Product Change Notice (PCN)

PCN Number: **PCN-0450882R-01**

Product(s) Affected: **PJ1-022-SMT-TR**

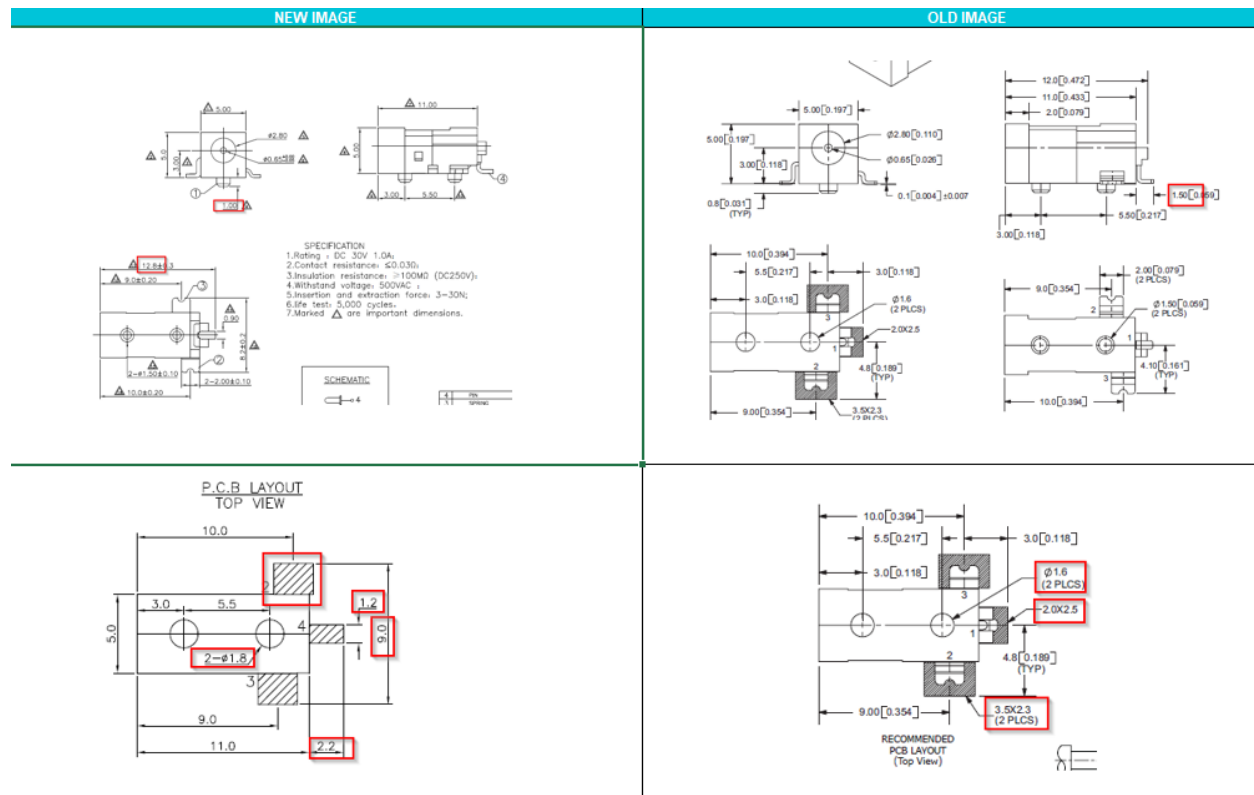
Description of Change: **Minor Housing and footprint differences. Material Change on the housing and terminals. See image Below**

Center Pin: Brass to Bronze
Terminal 2: Copper Alloy to Brass
Plastic: PA6T or Equivalent to PA10T
